**NAVFAC SPECIFICATION
08-1428**

AMENDMENT NO. 0003

14. DESCRIPTION OF AMENDMENT/MODIFICATION (Organized by UCF section headings, including solicitation/contract subject matter where feasible.) P1227,BEQ WOUNDED WARRIOR BATTALION, MCB, CAMP LEJEUNE, NORTH CAROLINA RECEIPT OF PROPOSALS REMAINS 7 NOVEMBER 2008 @ 2:00 PM NO MORE BID INQUIRIES WILL BE RECEIVED. SEE CONTINUATION SHEET sharon.taylor@navy.mil					
Except as provided herein, all terms and conditions of the document referenced in Item 9A or 10A, as heretofore changed, remains unchanged and in full force and effect.					
15A. NAME AND TITLE OF SIGNER (Type or print)			16A. NAME AND TITLE OF CONTRACTING OFFICER (Type or print)		
			TEL: _____ EMAIL: _____		
15B. CONTRACTOR/OFFEROR _____ (Signature of person authorized to sign)	15C. DATE SIGNED	16B. UNITED STATES OF AMERICA BY _____ (Signature of Contracting Officer)		16C. DATE SIGNED 28-Oct-2008

AMENDMENT 0003

FLOOR PLAN
SCALE 1/16" = 1'-0"

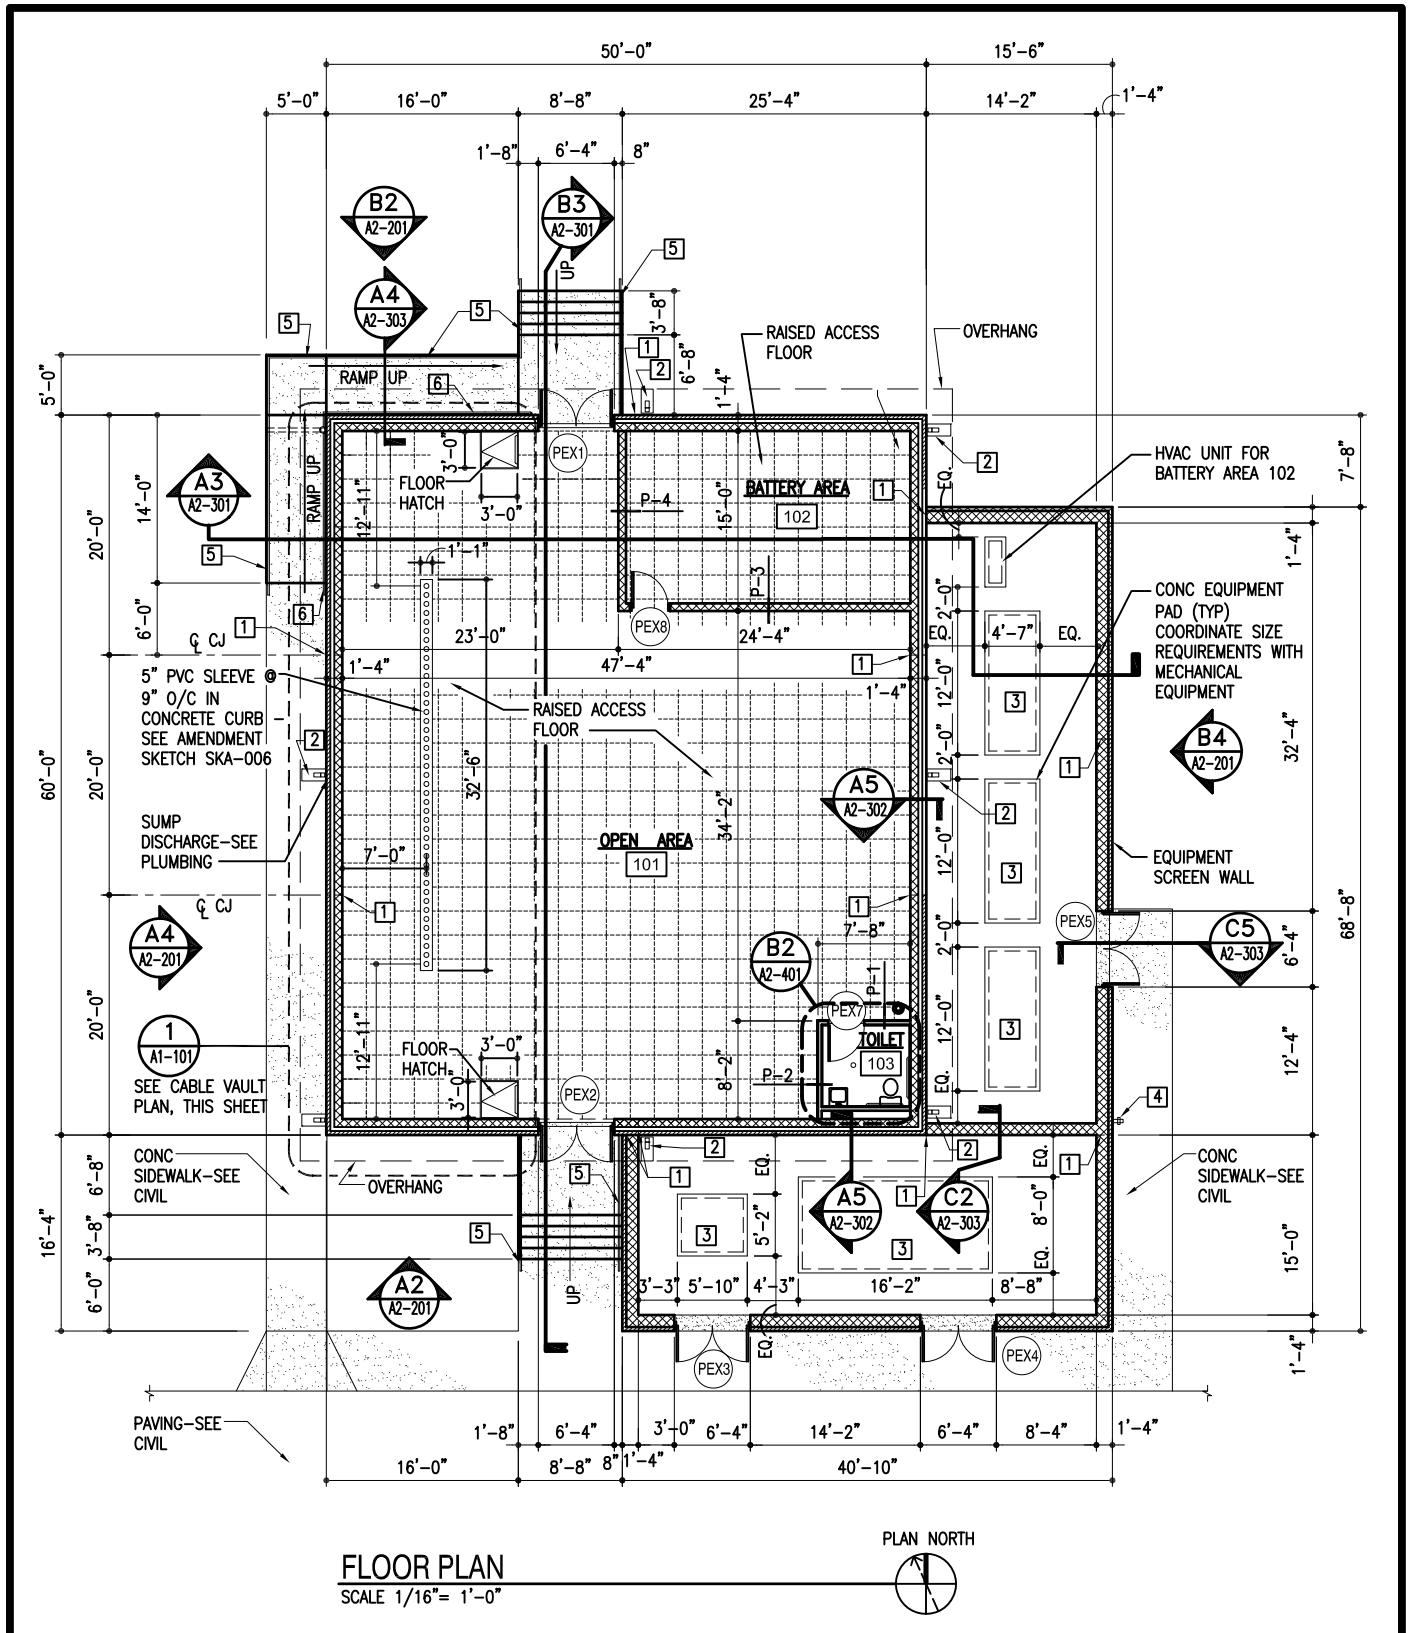
Floor Plan: Delete the floor plan shown and replace with Revised Floor Plan in sketch SKA2-001 which accompanies this amendment. Refer to A2-101 for NOTE LEGEND. Note that the FLOOR HATCH changed in size from 2’-8” to 3’-0” square.

PLUMBING FLOOR PLAN

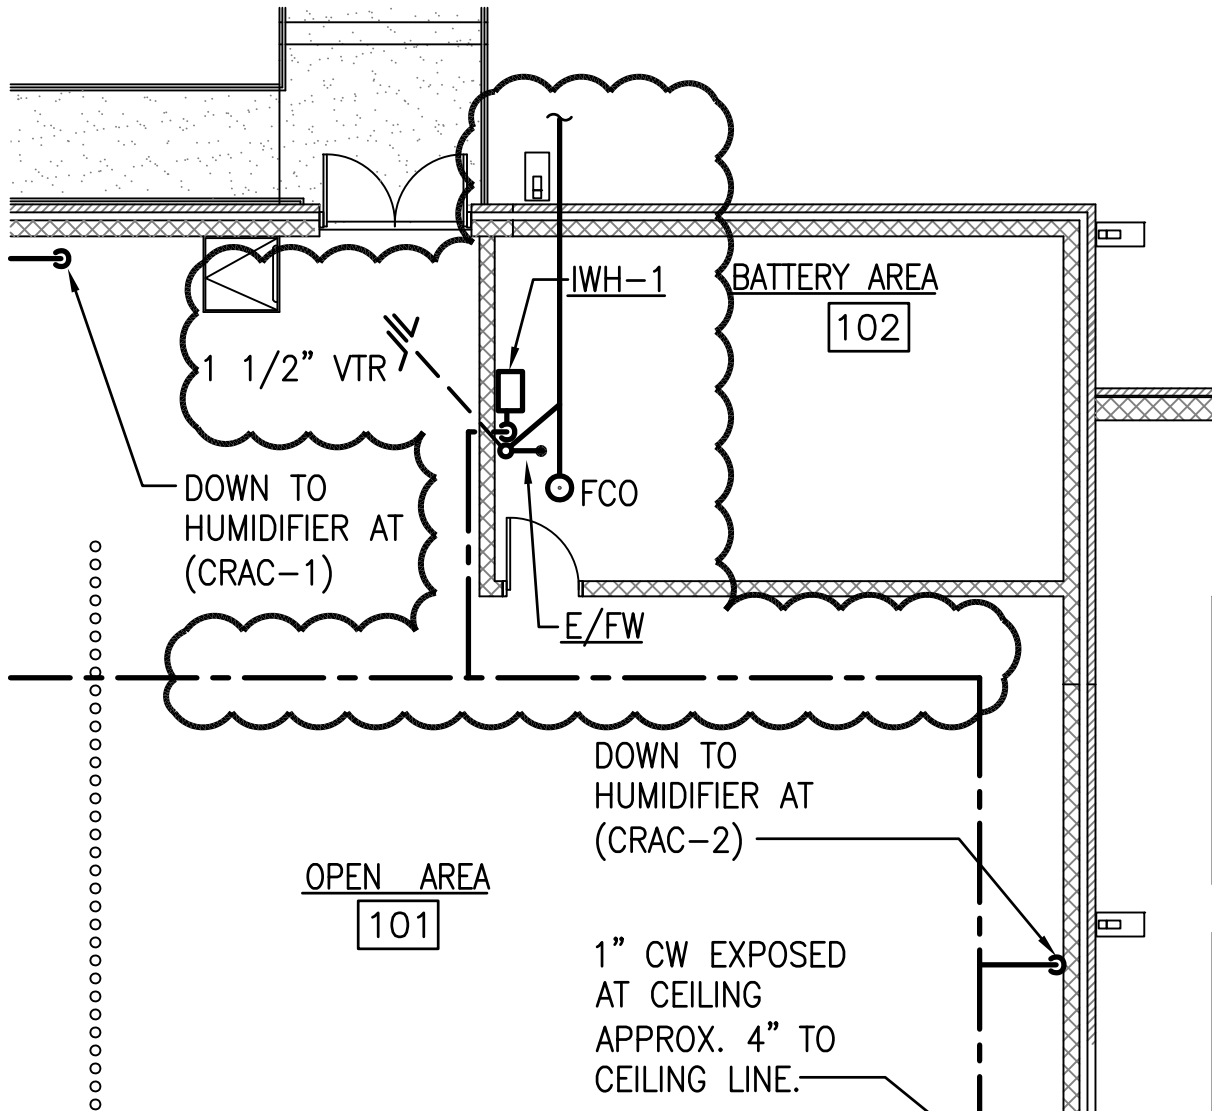
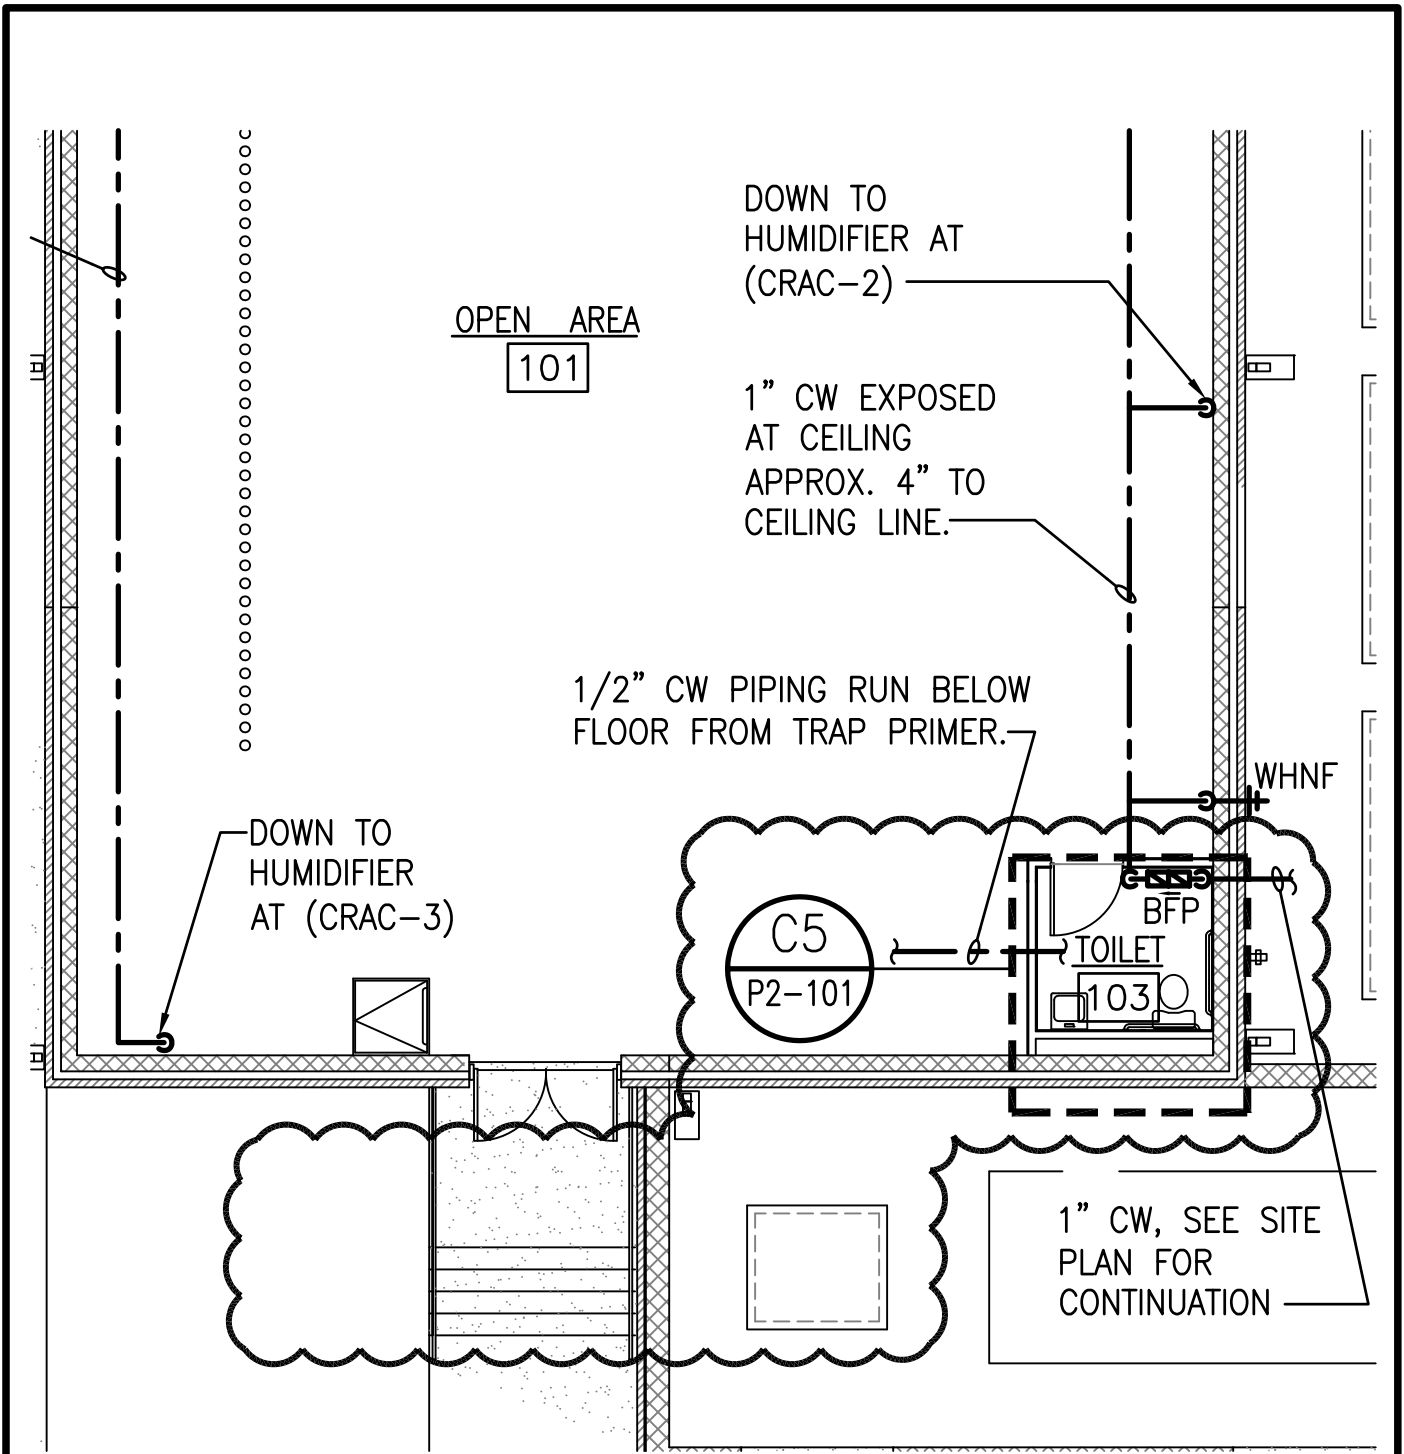
Sketch SKP2-005 is added to the list of drawings. This sketch accompanies this Amendment. Plumbing Floor Plan. The eye wash with associated instantaneous water heater is relocated to inside the Battery Area surface mounted on wall.

Sketch SKP2-006 is added to the list of drawings. This sketch accompanies this Amendment. Plumbing Floor Plan. The building domestic water back flow preventer is relocated to be exposed inside the toilet.

PLUMBING SANITARY WASTE, VENT & WATER RISER DIAGRAMS

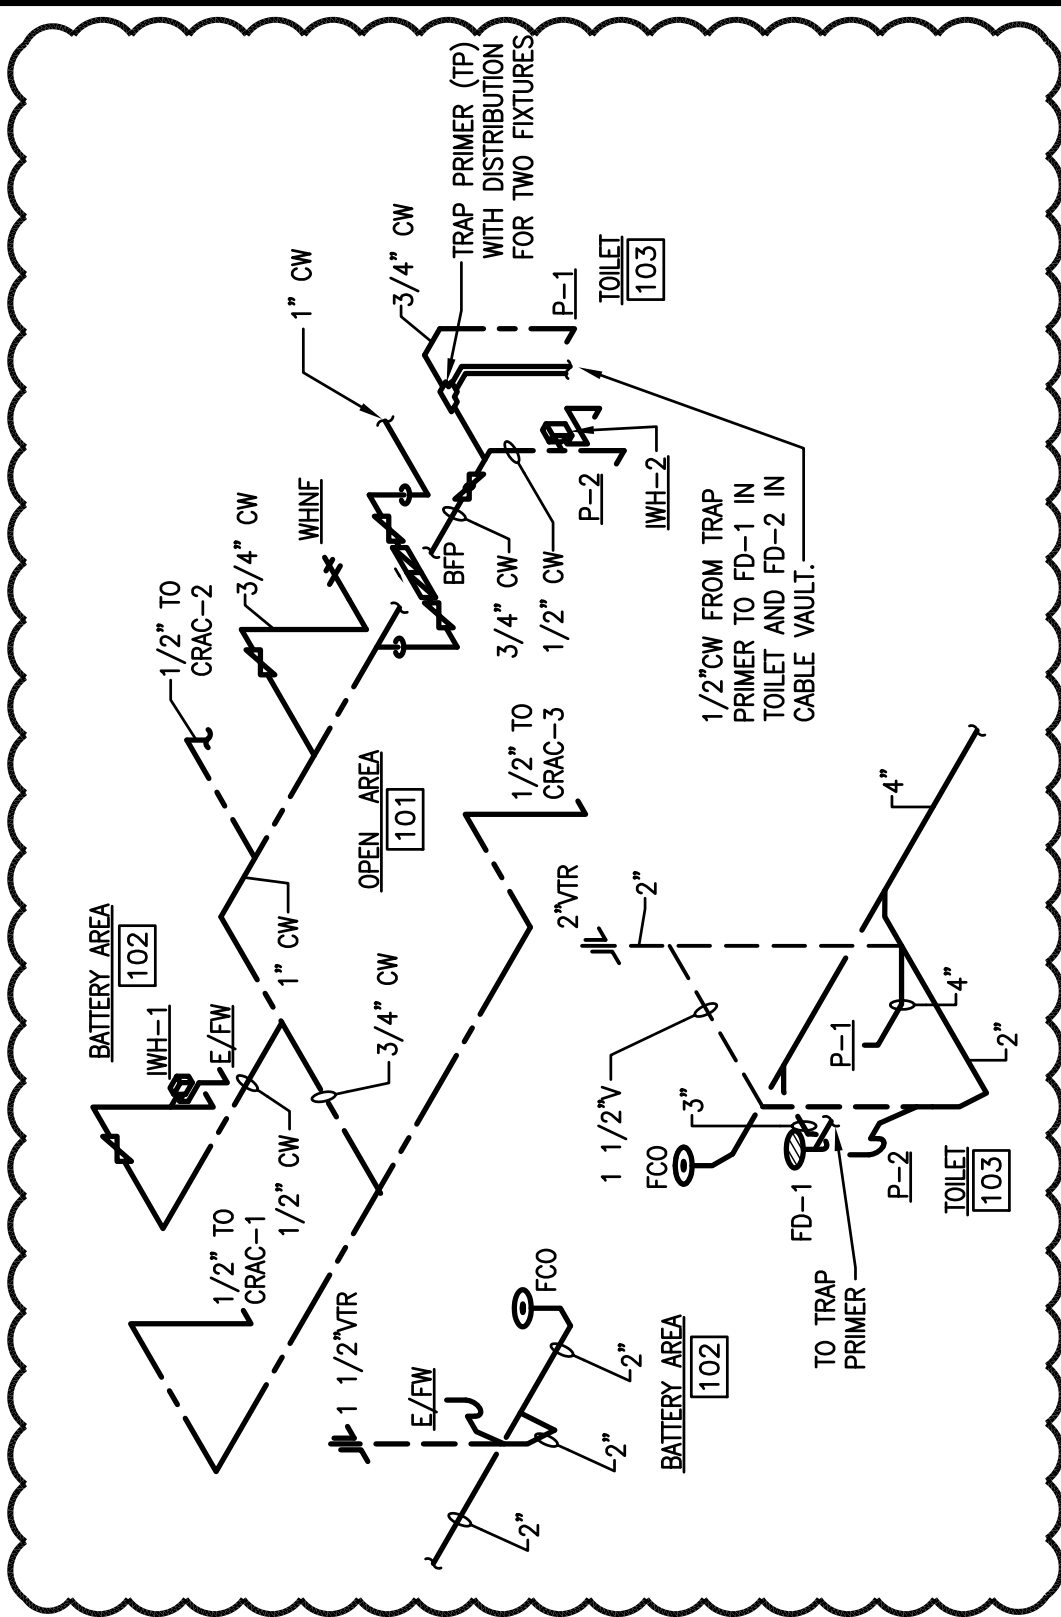
Sketch SKP2-007 is added to the list of drawings. This sketch accompanies this Amendment. Plumbing Sanitary Waste & Vent & Water Riser Diagrams . Water piping riser diagram adjusted to reflect the piping changes made in sketch SKP2-001 as shown in sketch SKP2-005 and SKP2-006.

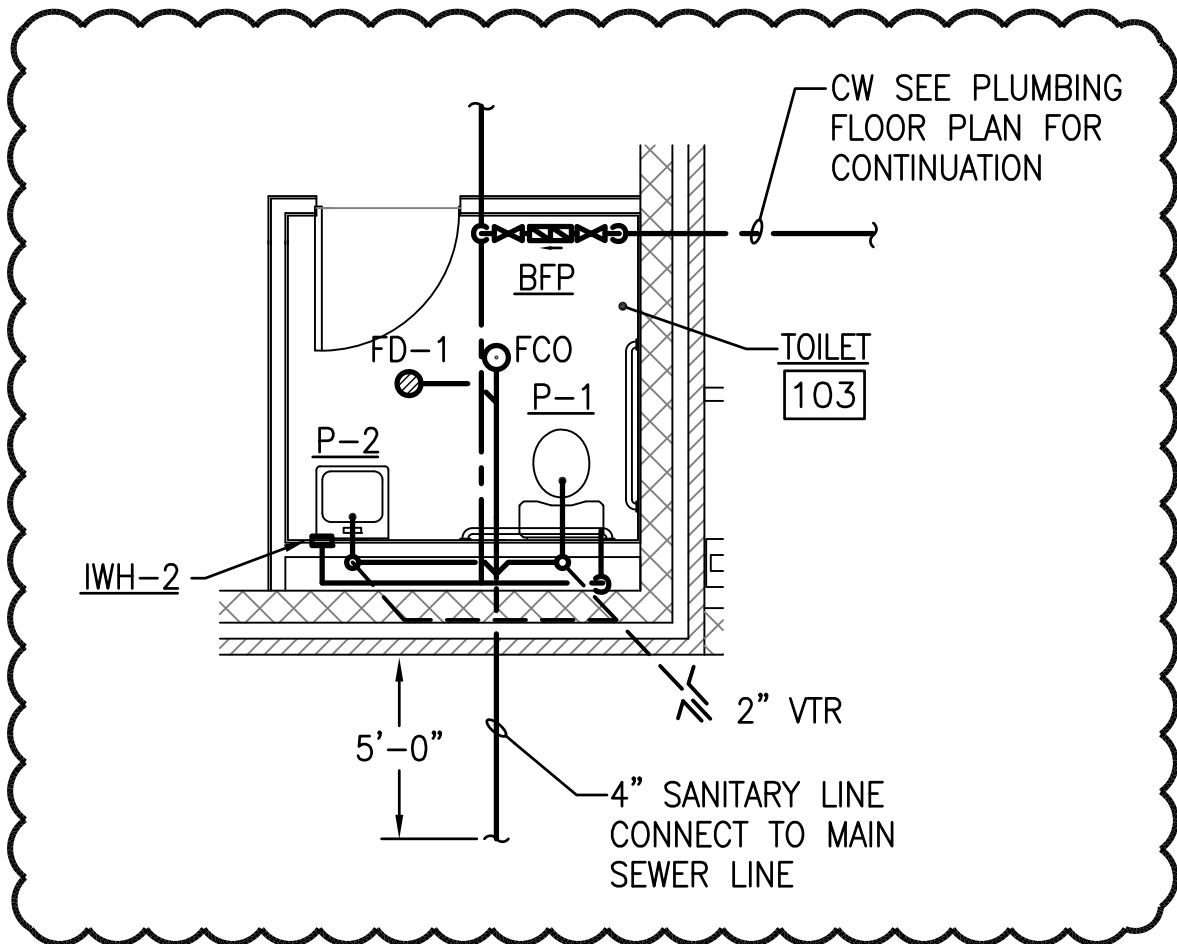
Sketch SKP2-008 is added to the list of drawings. This sketch accompanies this Amendment. Plumbing Enlarged Floor Plan C5. Toilet room 103 relocated within building. Relocated water line to enter the toilet room 103, exposed with backflow preventer.

TELEPHONE EXCHANGE FLOOR PLAN
1/16"=1'-0"

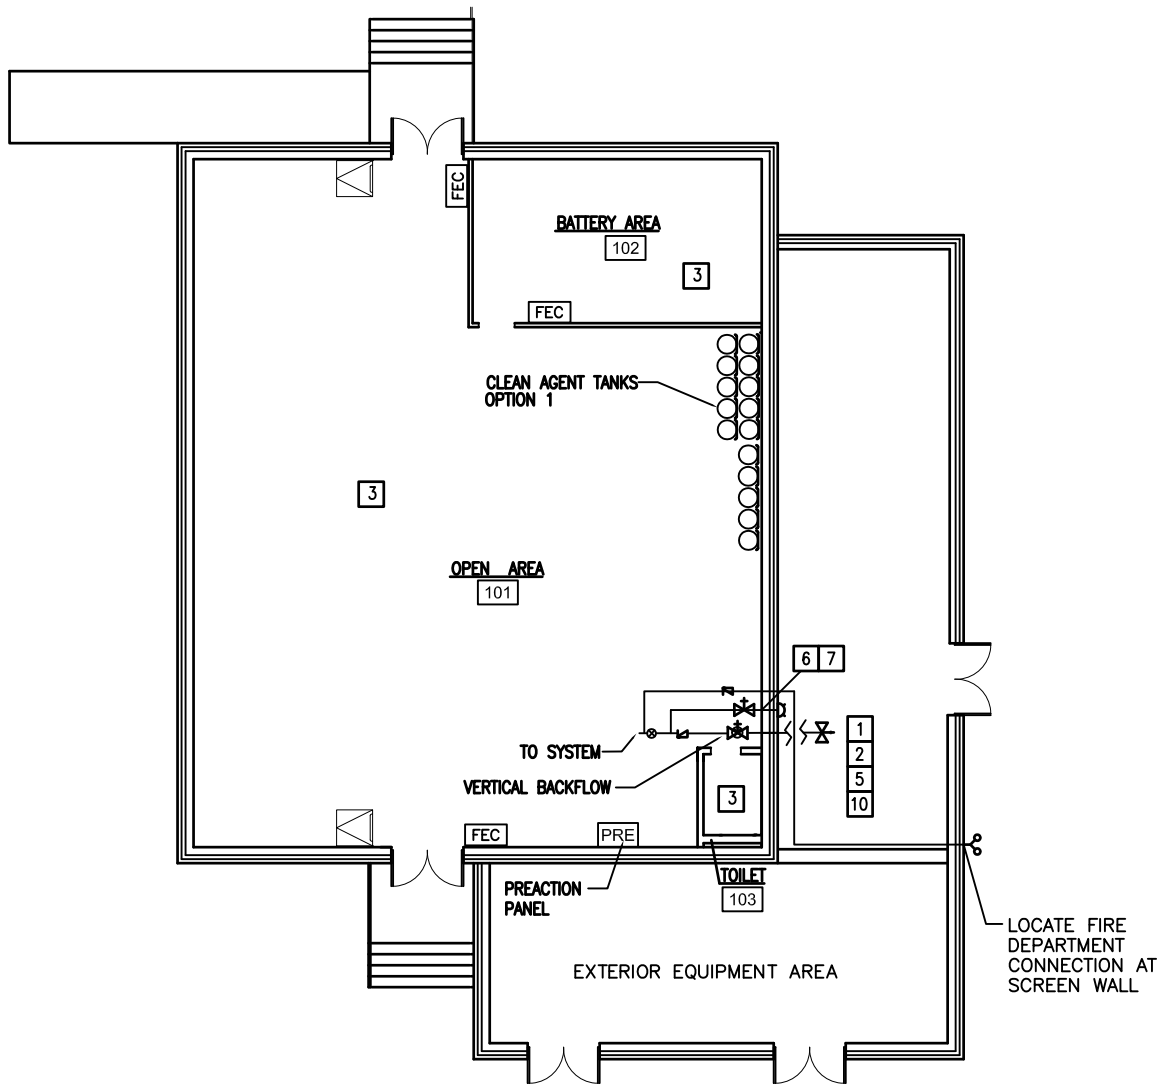
Telephone Exchange Floor Plan: Delete the floor plan shown and replace with Revised Floor Plan in sketch SKFX2-001 which accompanies this amendment.
